MANDATORY SERVICE BULLETIN

IS-28M2/EO-10

IS-28M2

ADDITIONAL INSTRUCTIONS CONCERNING THE

Fig. 1

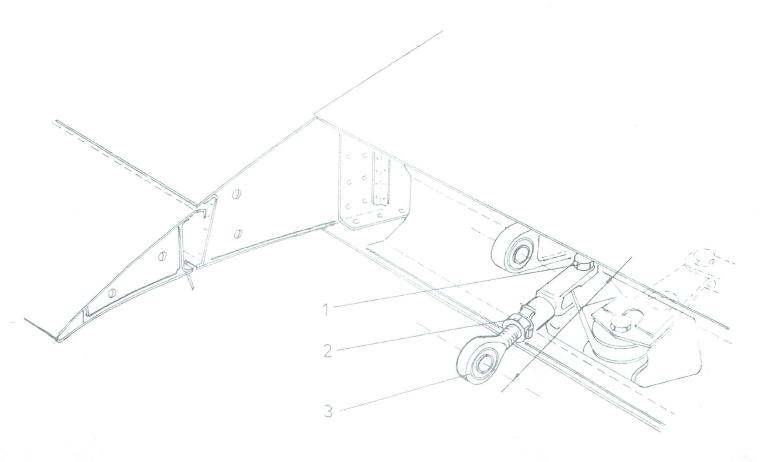
Visually check the control rod, proceeding as follows; (see Figure 1, page 6/6).

- (a). Remove the control rod from the wing lever by unlocking and by removing the nut and screw (item 1);
- (b). Measure the control rod length between the attachment pins axles at ends (size "l") to avoid some possible later adjustments;
- (c). Unlock the nut (item 2) and remove the eye (item 3).
- (d). Visually check the eye; if bent replace it with a new one.
- (e). Reassemble the parts, in reverse order, adjusting the rod length to size "1".

Fig. 2

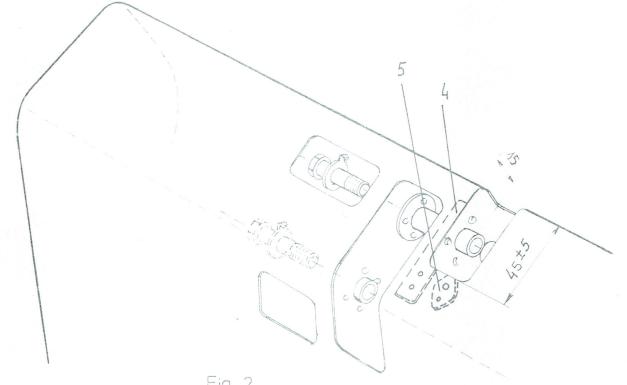
Check the control cables turnbuckles lock wires for elevator and rudder and replace them if corroded or cracked. Visually check the control red actuating the ailerens, after its removing from wing and replace it with a new one if bent. Enlarge the cut-out in the aileren leading edge (through which the above mentioned rod passes) according to the dimensions on page 6/6 figure 2.

Enlarge the cut-out in the ailerens leading edge to the dimensions indicated on page 5/5, figure 2, by using a mill. Check the doubler item 4 (fig.2) riveting to the skin. The number of rivets item 5 (fig.2) shall not be reduced by milling to less than 2 (if required, a new rivet shall be driven in). One of the rivets fastening the binding nut item 5 (fig.2) can be removed by milling. If the recommended modification is also applied to point 3, third paragraph, the original rod is replaced with a new one made of real), after having been adjusted to the length "l". If, applying the point (d) above, the eye is found distorted and the Buyer does not possess a spare part, on request, all the rods (made of steel) shall be delivered, applying thus directly the recommended modification.
